RE: DesignPro Ltd - File ref. FS 006821

**Response to Submission 3**

**Submission 3**

Figure 1: Proposed foreshore licence area with no overlap on quay or landing area

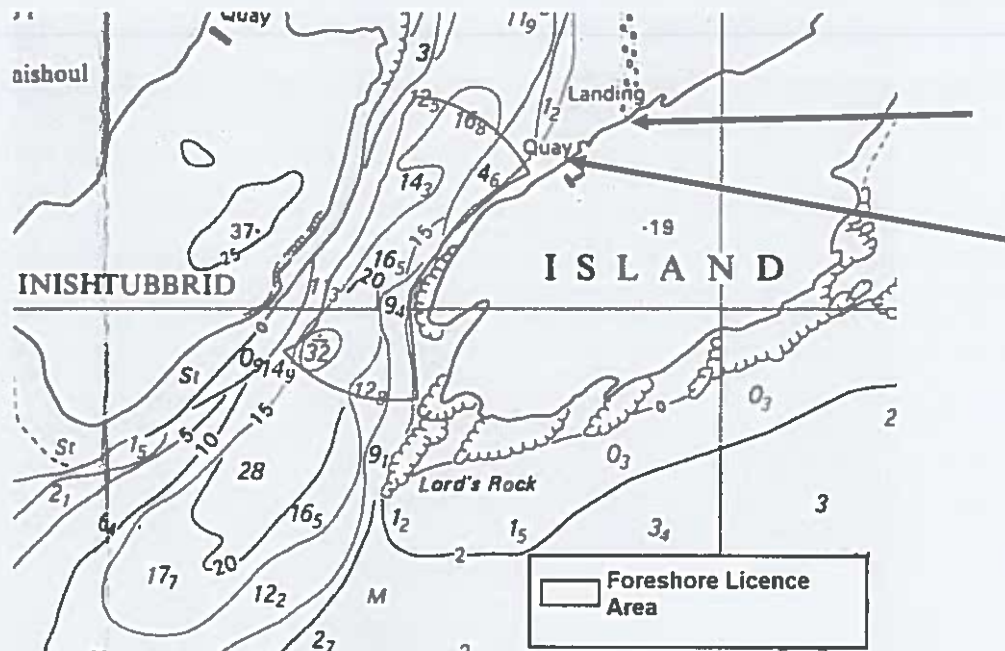
As can be seen in Attachment 3.4 and on closer view in Figure 1 below, the designated foreshore area central to this application does not preclude the island user from access to their quay or landing place.

In the event that the proposed foreshore area does preclude the navigational access to this landing place DesignPro will be, subject to adequate health and safety training and in compliance with insurance policies, open to permitting the passage of island owners through the proposed licence area during the 12 months of its licence.

Figure 2: Third-octave spectral levels for turbine noise adjusted to a standardised distance of 1m from the source, compared to the 20-minute ambient noise sample (Elsaesser et al., 2015).

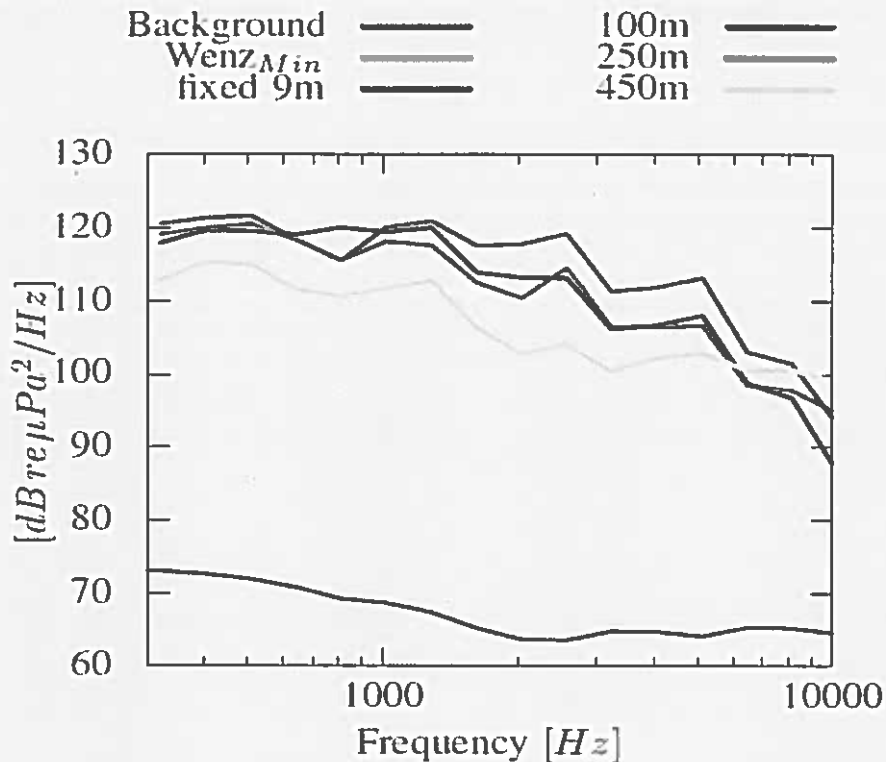
Noise and sound pressure impacts on the marine environment will also remain well within recommended root-mean-square (rms) sound pressure level (SPL) of 140 dB re  $\mu\text{Pa}$  in the 100Hz band in line with the industry best practice and standards outlined in previous studies (see figure 1 below) (Elsaesser, Coffin, Hood, & Starzmann, 2015; Halvorsen, Carlson, & Copping, 2011; Matthews, 2012).

Figure 5.2: Airborne noise levels from 25kW device (fully exposed motors)

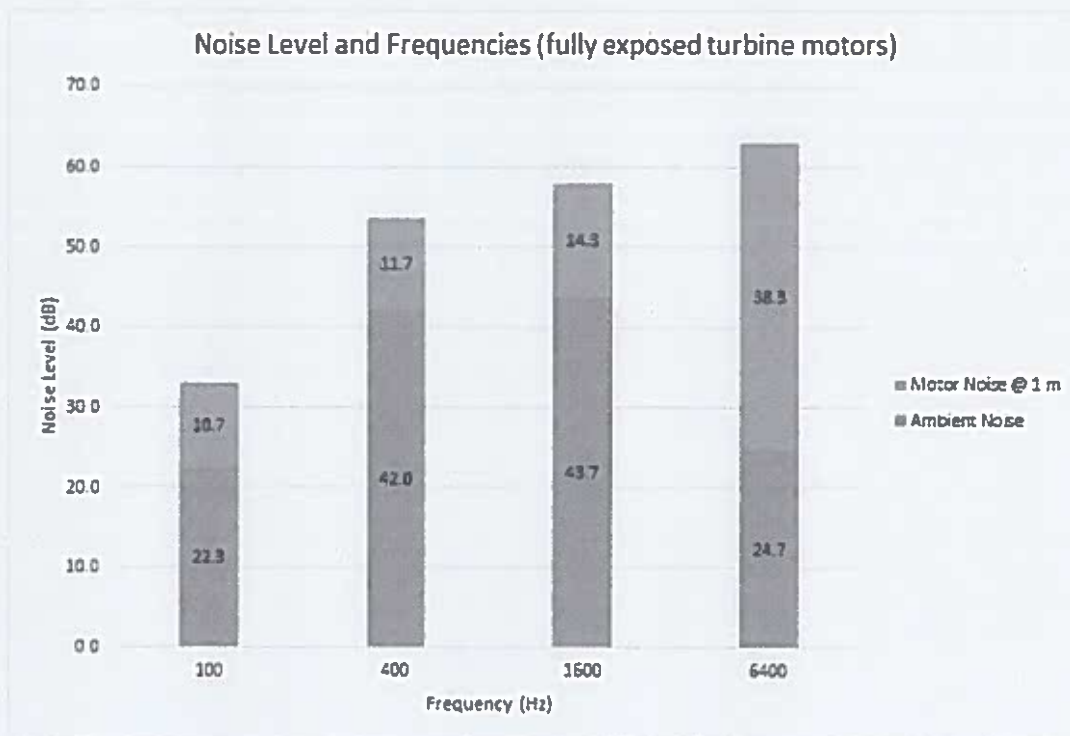
While no data is available on underwater noise levels from the 60kW device, airborne noise levels at 1m distance from the fully exposed motors (which are above the water line) of the 25kW device range from 33dB to 63dB with a frequencies ranging from 0.1 to 6.4 kHz (see Figure 5.2). In reality, these are worst-case noise levels as the motors on the 60kW will be fully sealed and housed. As there is no mechanical or electrical sound sources located below the waterline, the underwater noise level will be significantly lower than the airborne levels, which are significantly lower than mean background

noise levels in the Shannon. The noise levels generated by the 60kW device in the <500Hz range are below the possible audible levels of lamprey.

*Figure 3: Visual representation of 60kW device in the water. Note the limited visible section of device above the waterline.*

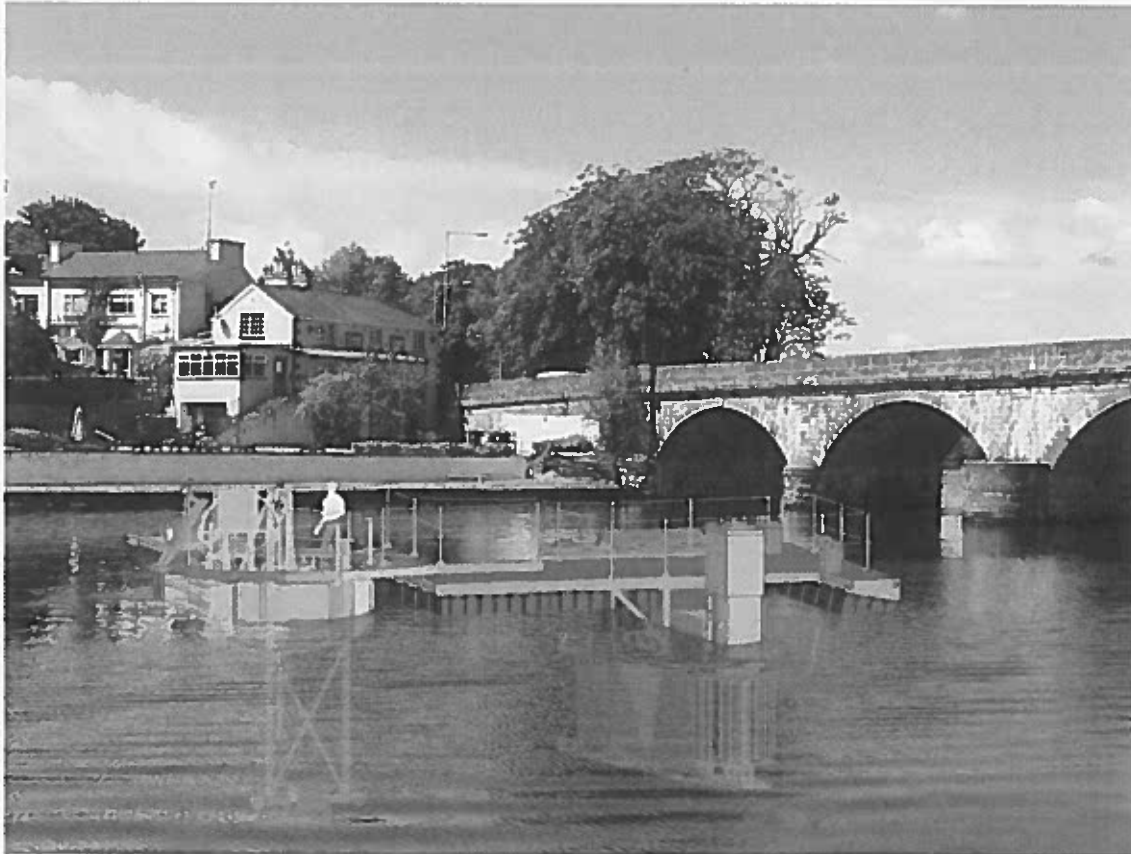
There will be no significant impacts on the landscape. Visually the device will have a very small footprint (see image below) and will not be visible from the landward side of the estuary given its proposed deployment location just west of Canon Island. Inishtubbrid Island will serve to screen the device further from view during the stage of testing. In relation to Canon Island, there is one derelict farmhouse on the island which is over 200 years old. The house on the island has not been habituated in a number of years. Given the orientation and location of the farmhouse on the island coupled with the screening which is provided through the presence of mature trees there is no potential for visual impacts arising from the temporary placement of the device within the channel between Inishtubbrid and Canon Island. (Please see Appendix 1 for Plates 1 & 2 and Figure 2 Location of Farmhouse with respect to tidal device). The 2013 Business and Tourism Feasibility Study on the Shannon Fergus Islands also highlighted that "much of Canon Island is heavily overgrown with shrub and woodland and is currently very difficult to access". This further emphasises the screening

In addition to above, a computer generated image of the minimal visual impact which the 60kW device will have at the proposed site can be seen below.
